# ASSESSMENT OF DEVELOPMENT APPLICATION

DA 2021/219 – Pacific Drive, Port Macquarie

## PLANNING ASSESSMENT REPORT

Figure 5 17.5m Height plane showing height exceedance – looking west

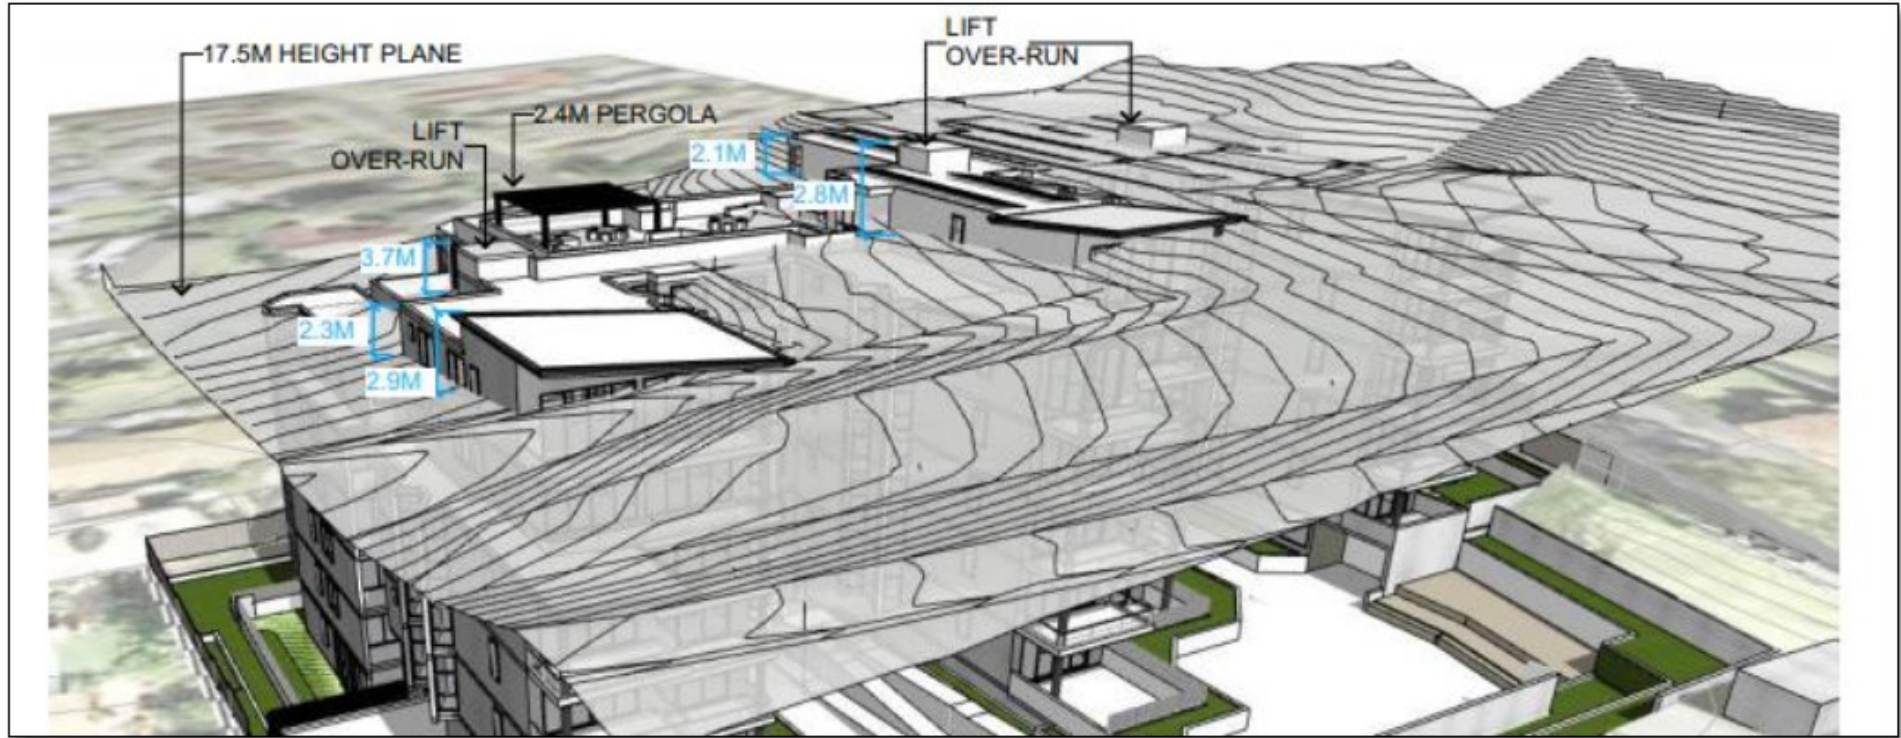
Comment	Compliance Status
<ul style="list-style-type: none"> <li>With respect to views and the height variation, the areas of exceedance are generally in the central to central-southern area of the roof. The potential for view loss is from the northern properties only and the height variation in that area relates to a lift overrun only. The site could accommodate a larger, bulkier development than proposed and closer to the eastern boundary which would further obstruct views and result in a taller building due to topography, which would obstruct more views and has the potential to remove a large majority of water views. However, this is not what is proposed, and the building's siting and design is considered to be appropriate having regard to view sharing and reasonableness. Further, the views experienced are over a vacant private parcel of land, which has provided borrowed amenity for the residents for a large number of years. Council's planning controls for the area have envisaged this form of density on this land and a varied design would likely result in some obstruction of views in order to achieve the desired planning outcome for this area. The view impact of the proposed development is considered acceptable and the view sharing reasonable and equitable.</li> <li>Given that the FSR control is not exceeded by the overall development, there is no additional floor space benefit from the height variation and therefore no environmental impacts related to floor space.</li> <li>The additional height does not impact upon noise generation, pedestrian or vehicular access, waste management, heritage, drainage or services.</li> </ul> <p>It is considered that the proposal is consistent with the relevant objectives of the Development Standard and for the R3 Medium Density Residential zone. The proposed exceedance in maximum permissible building height does not significantly increase the bulk and scale of the proposed development, cause any additional view loss from neighbouring properties, or surrounding residential properties or have any significant additional adverse scenic/visual impacts or amenity (privacy/overshadowing) impacts on the public domain.</p> <p>Overall, it is considered that compliance with the Development Standard is unreasonable and unnecessary in this instance, and that there are sufficient environmental planning grounds to justify the variation.</p>
